STATE OF MAINE
DEPARTMENT OF HUMAN SERVICES
AUGUSTA, MAINE 04333

March 30, 1977

Subject: Waiver to the Maine Plumbing Code, Part II,
Ziebart Store, Leighton Road, Augusta

Site Plan

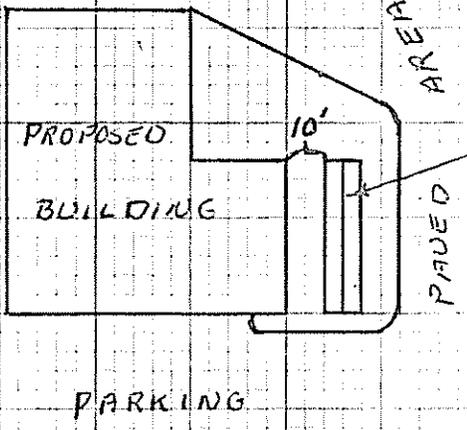
This will acknowledge receipt of a waiver request and a plan with soils information by William Rideout, Certified Site Evaluator, showing the proposed sewage disposal system for the subject project. It is not in compliance with the Maine Plumbing Code, Part II, because of distance of the chamber system to the building, the reason for the waiver request.

In consideration of the plan dated March 18, 1977, and recommendations by Mr. Rideout, and Richard Baker, Local Plumbing Inspector, this office will grant the responsible Local Plumbing Inspector the right to waive certain provisions of the Maine Plumbing Code for the following disposal system under authority of Section 10.3.

The installation of a 1000 gallon septic tank to be followed by the installation of 10 type "B" chambers. Chambers shall be at least 10 feet from the building slab.
